DEVELOPMENT REVIEW COMMITTEE

CASE COMMENT REPORT

CASE NO. UDP-S24060

CASE	UDP-S24060
PROJECT NAME	Florida House
APPLICATION TYPE	Site Plan Level II Review
APPROVAL LEVEL	DRC, Subject to Commission Request for Review
REQUEST	Change of Use from Residential to Bar
APPLICANT	515, Inc.
AGENT	Jason Crush, Crush Law, P.A.
PROPERTY ADDRESS	515 NE 4th Street
ABBREVIATED LEGAL DESCRIPTION	Resub Blk 32 North Lauderdale 5-25 B E1/2 Of Lot 22, Lot 23 Blk 32
ZONING DISTRICT	Regional Activity Center - City Center District (RAC-CC)
LAND USE	Downtown Regional Activity Center
COMMISSION DISTRICT	2- Steven Glassman
NEIGHBORHOOD ASSOCIATION	Flagler Village Civic Association
SUBMITTED	September 06, 2024
COMPLETENESS ISSUED	February 7, 2025
EXPIRATION	June 7, 2025, (120 Days)
WAIVER	Not Requested
CASE PLANNER	Adam Schnell, Urban Planner III

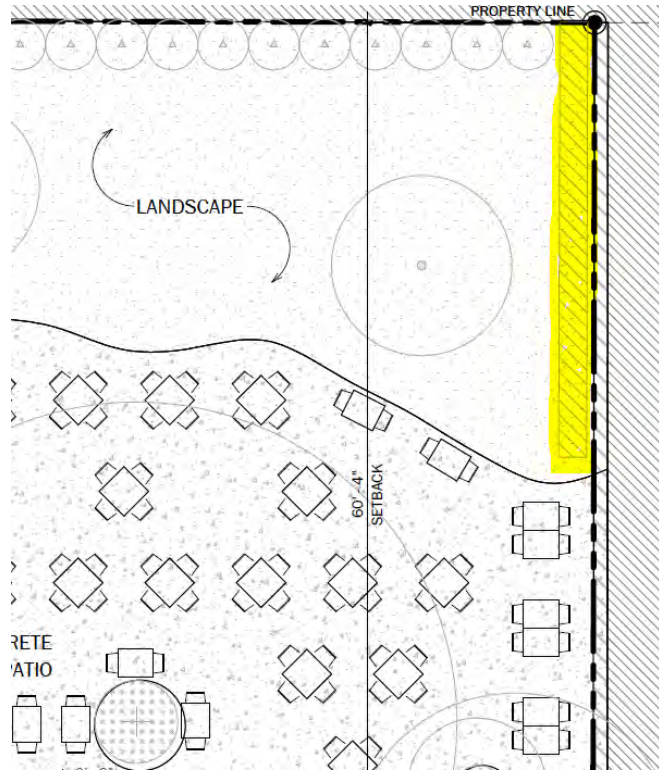
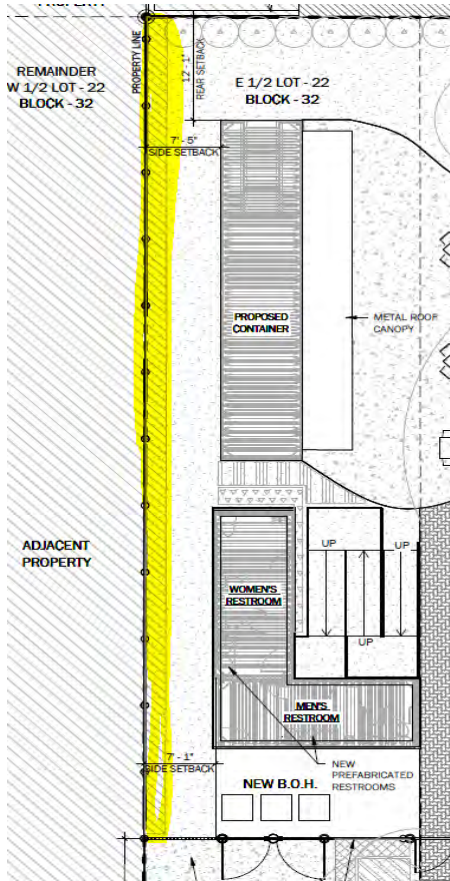
- a. S3- Provide on street parking spaces and match local DMP street sectional.
- b. S5 through S7 and S9- Provide street trees along the ROW per the requirements of the DMP.

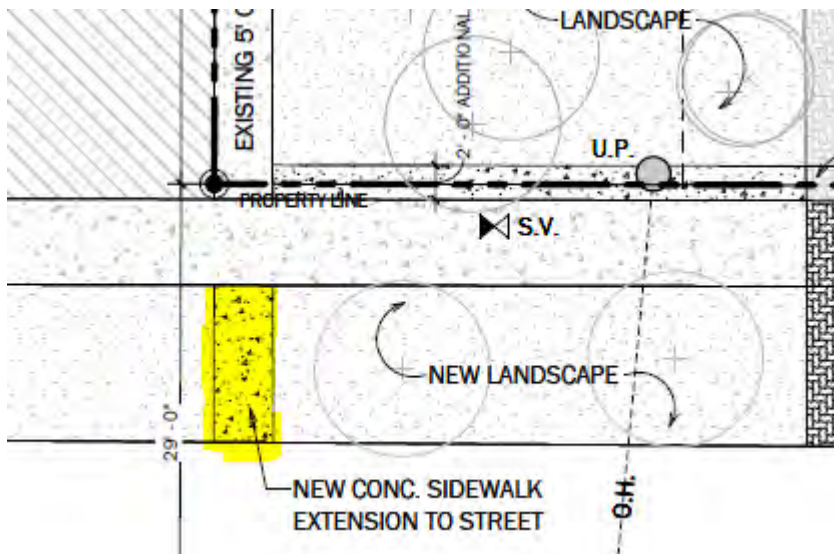
- g. Identify the location of all mechanical equipment. Any equipment that is visible from the ROW must be properly screened.
 - h. Clarify the highlighted dashed lines areas in the image below:.

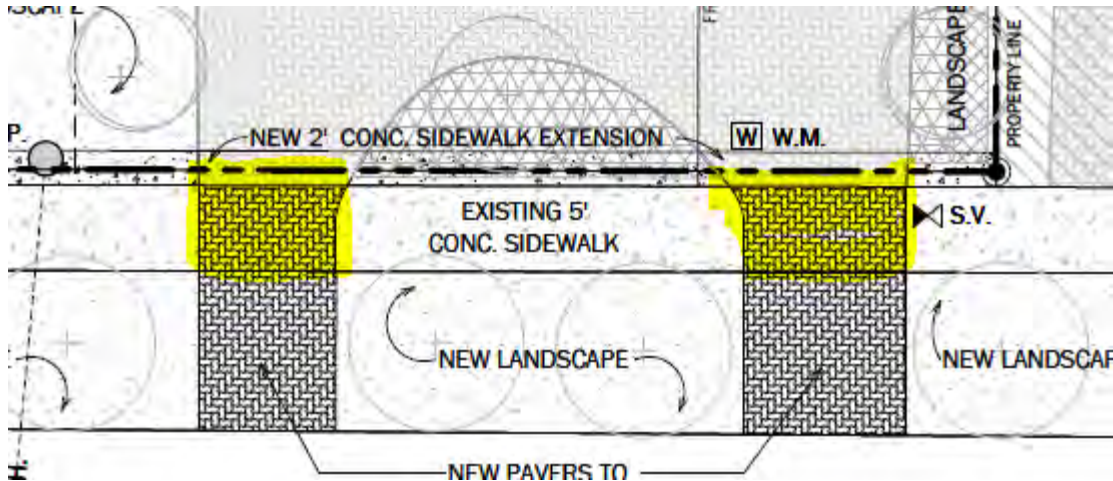
i. Remove sidewalk from swale.

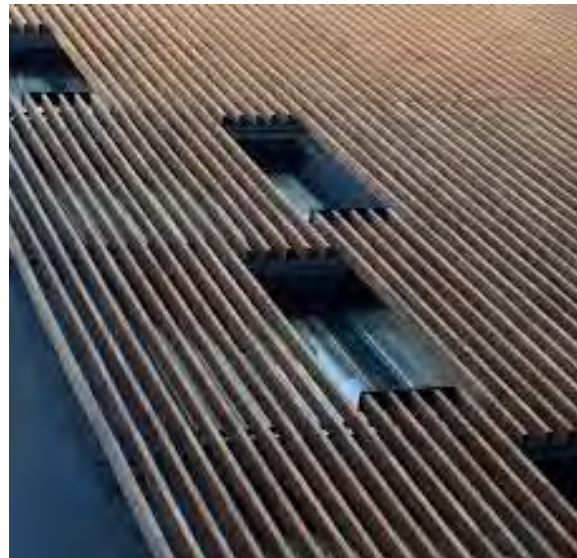
- 9) Provide the changes on the elevations:
- a. Per the DMP, creative facade compositions are required, with the layering of architectural elements. Provide additional architectural elements that enhance the building's front façade. Examples include, but are not limited to metal, wood, or faux composite battens/slates, and sconced lighting. Other examples include Bahama shutters, enhanced cornice and trim, and architectural banding. See the following images for examples.
